Application No.: 10/584,426  
Filing Date: May 23, 2007

## REMARKS

In response to the Final Office Action mailed March 18, 2009, the Applicant respectfully requests the Examiner to reconsider the above-captioned Application in view of the foregoing amendments and the following remarks.

Figure 1

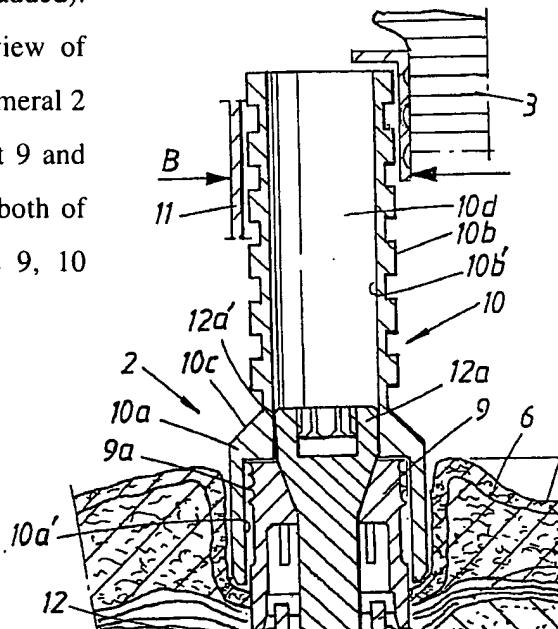
In the Office Action, the drawings were objected on the stated grounds that "it is not clear where reference numeral 2 is referring to or pointed to in figure 1. It appears that numerals 2 and 10a are pointing to the same element." *See* Office Action, page 2. Applicant has carefully reviewed the Examiner's comments and respectfully submits that reference numeral 2 properly indicates the spacer members, as described in the present Application. In particular, paragraph [0013] indicates that,

Accordingly, as illustrated at right in partial view of Figure 1 of the present Application, reference numeral 2 is spaced apart from the first sleeve-shaped part 9 and the second sleeve-shaped part 10 and points to both of the parts 9, 10 in order to refer to the parts 9, 10 collectively.

Accordingly, Applicant respectfully submits that reference numeral 2 clearly refers to or points to the parts 9, 10, as supported by and referred to in the specification. Therefore, Applicant respectfully requests that the objection to the drawings be withdrawn.

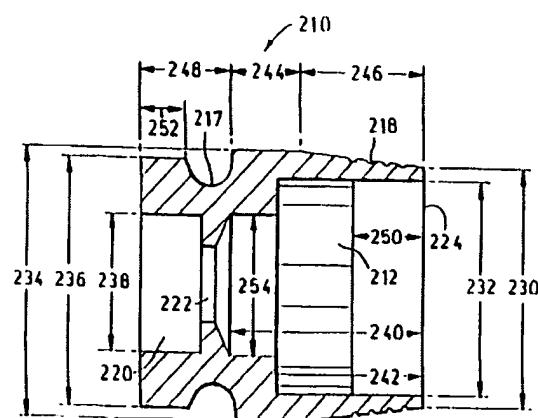
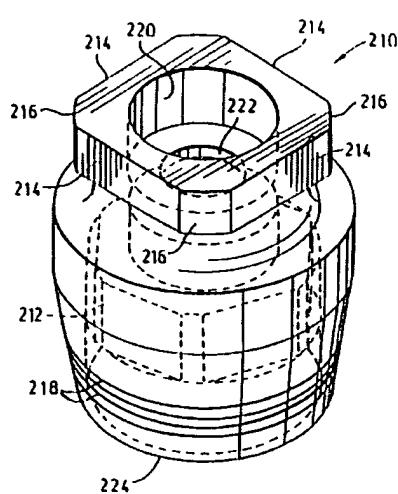
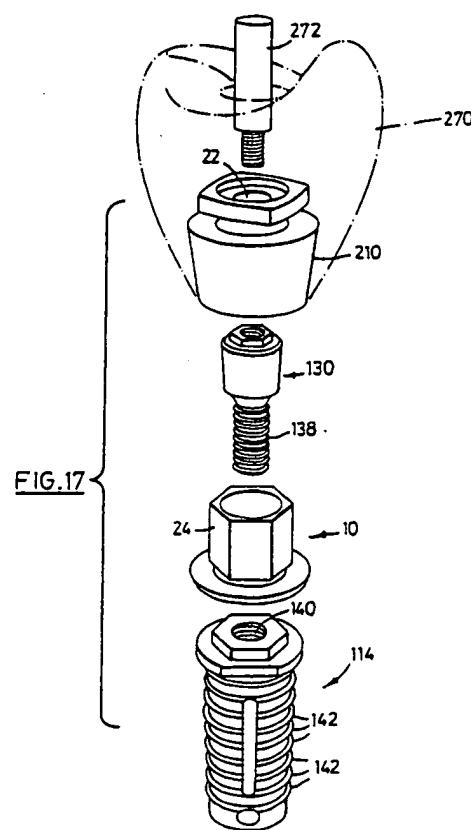
Figure 17 of the Kwan reference is shown at right and illustrates an exploded view of the Kwan implant assembly. With reference to Figure 17, the Kwan implant assembly includes a gold coping 210 that is used to interconnect the tooth 270 to the abutment 10. *See id.* at col. 10. The abutment 10 is fastened to the implant 114 using the first screw 130.

With continued reference to Figure 17 of Kwan, after the abutment 10 is fastened to the implant 114 using the first screw 130, the gold coping 210 is placed on the abutment 10 and fastened in place using the second screw 272. As best understood from Figures 14 and 15 of Kwan (shown below), as well as Figure 17, the first screw 130 is used only to fasten the abutment 10 to the implant 114 and is not used to fasten the gold coping 210 to the abutment 10. Indeed, it appears that the second screw 272 is solely responsible for securing the gold coping 210 to the abutment 10. *See also* Kwan, col. 12, lines 5-17.

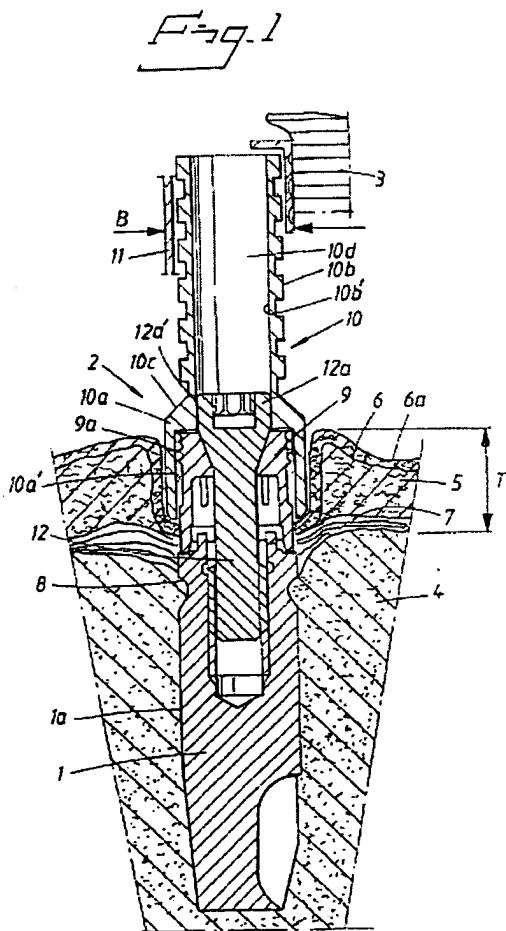
Figure 2 of the Applicant’s Application, shown at right, illustrates an embodiment within the scope of Claims 1 and 2. The illustrated embodiment is configured with “expansion of the at least a portion of the first-sleeve shaped part for securing the second sleeve-shaped part to the first sleeve-shaped part.” As shown, the head 12a of the screw 12 contacts the first sleeve-shaped part 9 to cause it to expand outwardly while the second sleeve-shaped part 10 is fitted on top of the first sleeve-shaped part 9. In this manner, the outer surface of the first sleeve-shaped part is expanded against the inner surface of the second sleeve-shaped part to secure the second sleeve-shaped part to the first sleeve-shaped part.
